**SPARTANBURG COMMUNITY COLLEGE – TYGER RIVER BUILDING COSMETOLOGY
RENOVATION**
DUNCAN, SOUTH CAROLINA
OSE PROJECT # H59-N306-JM | ARCHITECTS PROJECT # 653251

RESPONSE TO PRE-BID QUESTIONS

Project Name	Spartanburg Community College – Tyger River Building Cosmetology Renovation
Project Number	H59-N306-JM
Date Issued	May 23 rd , 2025

INTERIOR ELEVATIONS

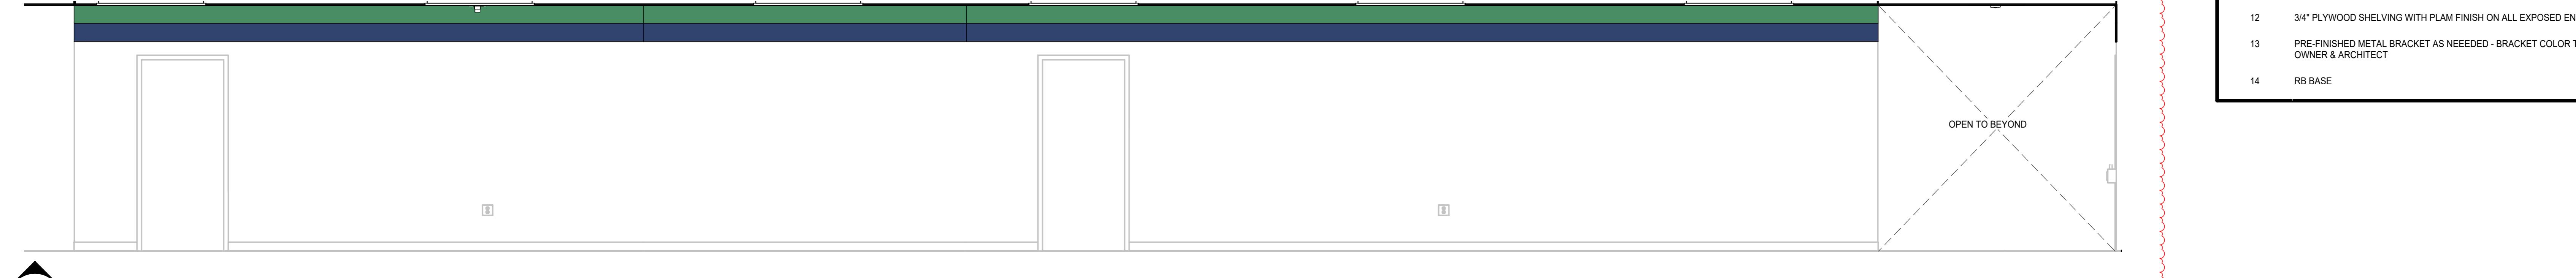
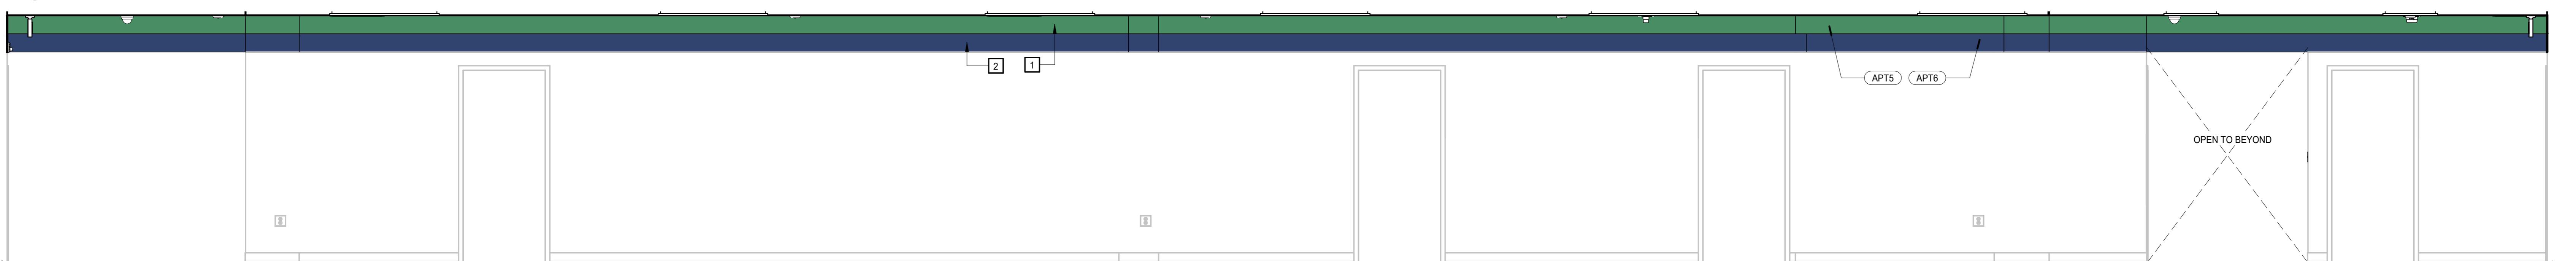
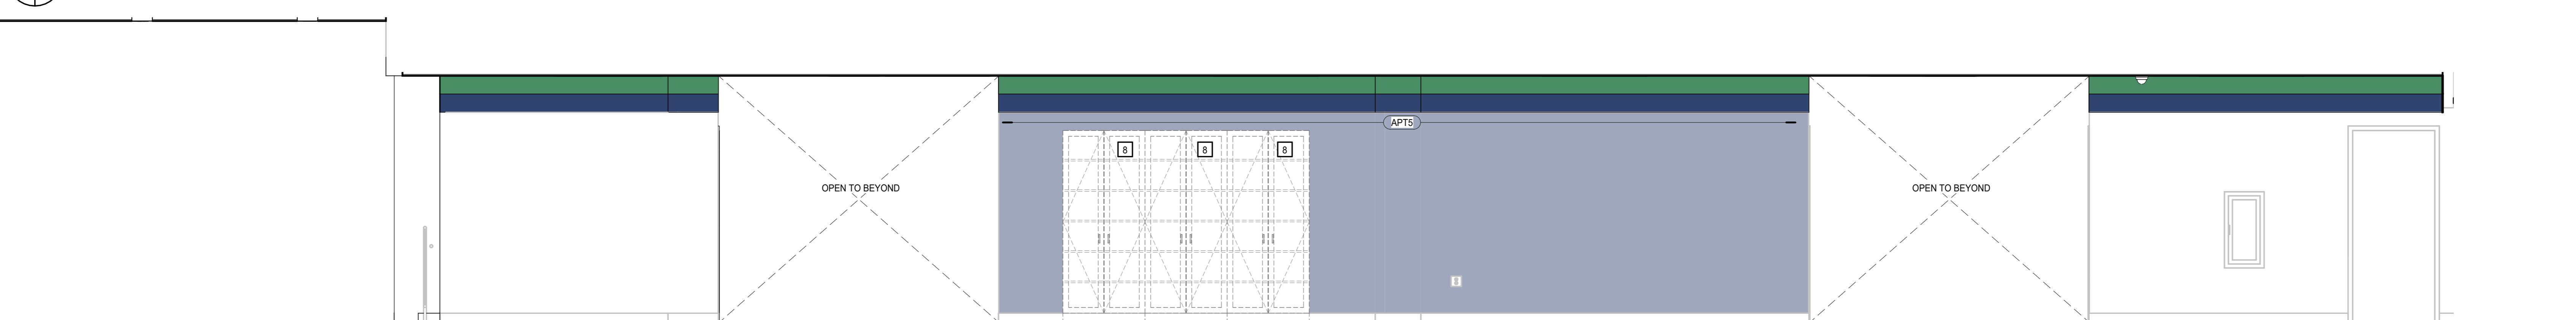
7. Accent paint bands in the corridors shall be 8" in width, interior elevations on sheets A4.2.1 and A4.2.2 have revised and included in Addendum No. 1.

12. Rubber wall base has been added to the wood knee/chase walls, see revised sheet A4.2.2.
13. Provide rubber wall base on all new interior partitions and patch rubber wall base where existing walls were demolished.

INTERIOR ELEVATION KEYNOTES	
REPRESENTED BY  	
APPLIES TO DRAWINGS A4.2 - A4.n	
ADDENDUM	NO.1
1	8" ACCENT PAINT - BLUE
2	8" ACCENT PAINT - GREEN
3	DOUBLE TIER WOOD LOCKERS - OFCI - REFER TO SPECIFICATIONS
4	HAIR WASH STATION - OFCI
5	PEDICURE SPA - OFCI
6	BUILD UP CASEWORK WITH PLASTIC LAMINATED FINISH
7	DOUBLE SIDE HAIR STYLING STATION - OFCI
8	GLASS DOOR CABINET FOR MERCHANDIZE - OFCI
9	PLASTIC LAMINATE ON 3/4" PLYWOOD
10	CPSF - NS 2 1/2"
11	WOOD SHELVING WITH PLAM FINISH ON PRE-FINISHED METAL BRACKET FOR MANNEQUIN HEAD STORAGE
12	3/4" PLYWOOD SHELVING WITH PLAM FINISH ON ALL EXPOSED ENDS
13	PRE-FINISHED METAL BRACKET AS NEEDED - BRACKET COLOR TO BE SELECTED BY OWNER & ARCHITECT
14	RB BASE

LOWER LEVEL
DEMOLITION PLAN
(ALTERNATE-1)

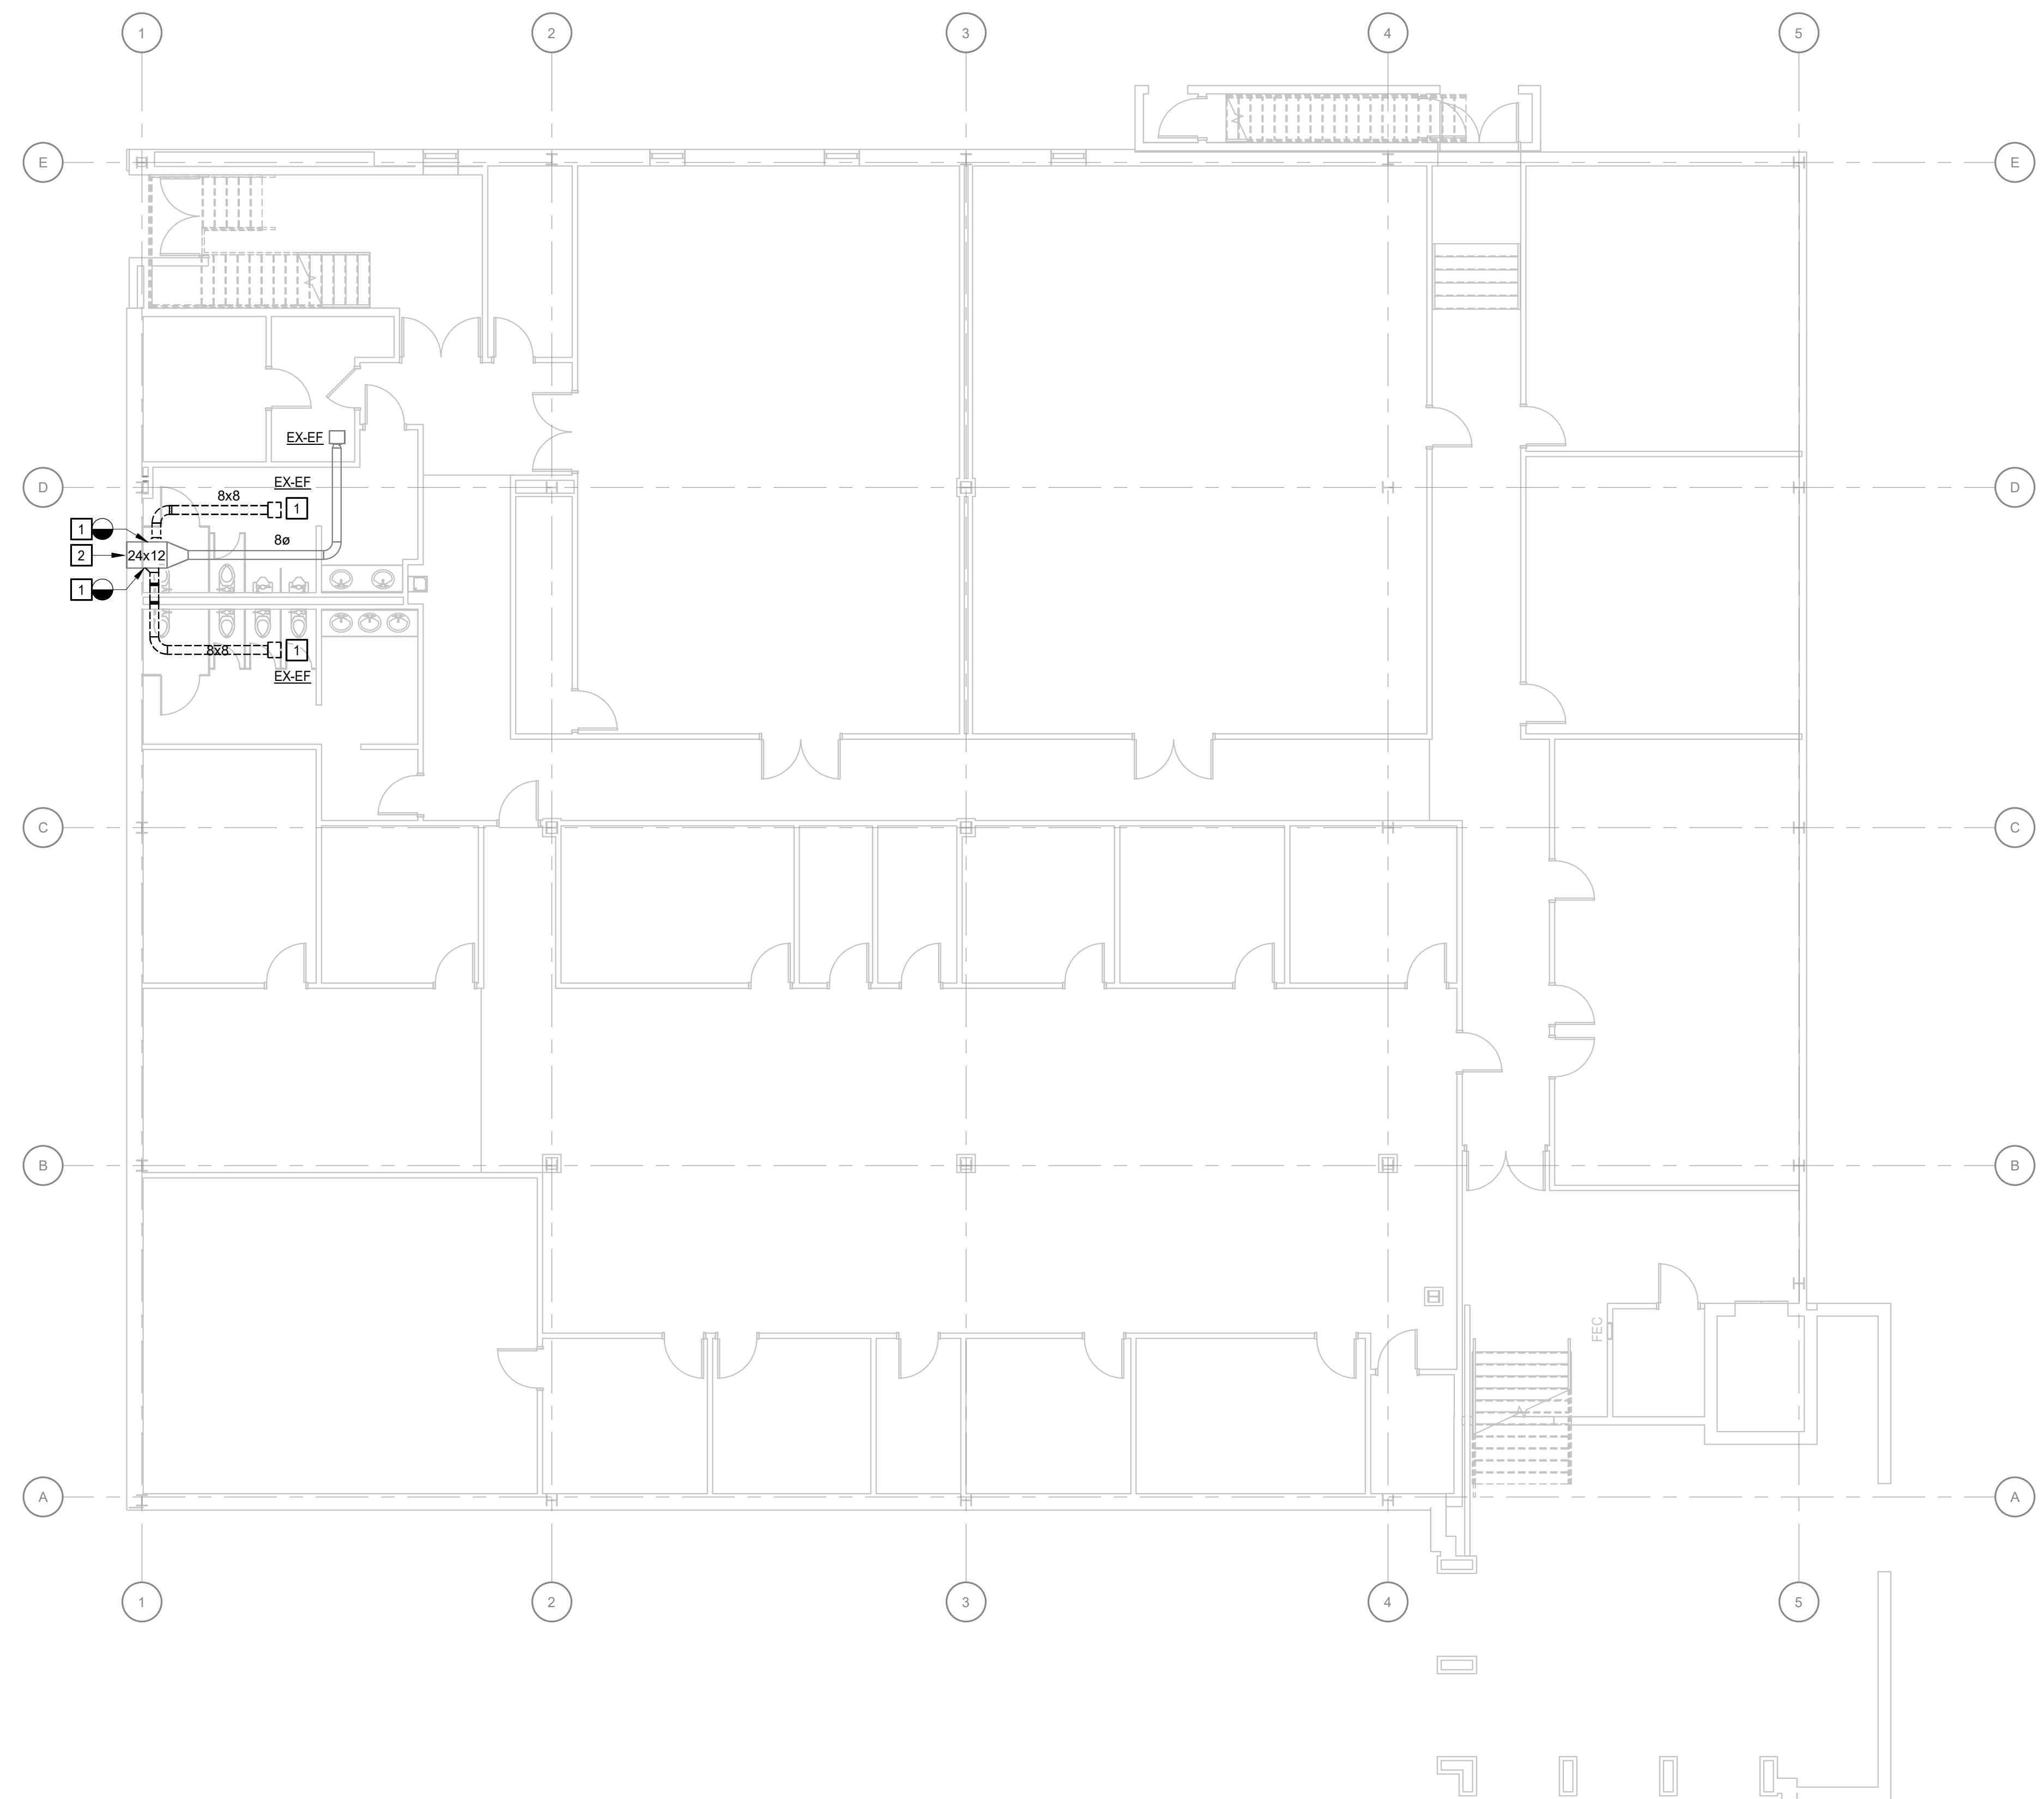
1. Mechanical drawings have been revised to indicate items to be removed during demolition are to be salvaged and turned over to the owner, as requested by the owner.

1. REMOVE EXISTING EXHAUST FAN AND ASSOCIATED DUCTWORK SHOWN DASHED AND DISPOSE.
2. EXISTING EXHAUST WALL LOUVER.

A. ALL EXISTING EQUIPMENT AND CONTROLS, CONTROLLER, VALVES AND THERMOSTATS ETC. NOTED TO BE REMOVED SHALL BE SALVAGED AND PRESENTED TO THE OWNER FOR DETERMINATION OF WHAT EQUIPMENT AND CONTROLS WILL BE RETAINED BY THE OWNER AND WHAT WILL BE DISPOSED OF.
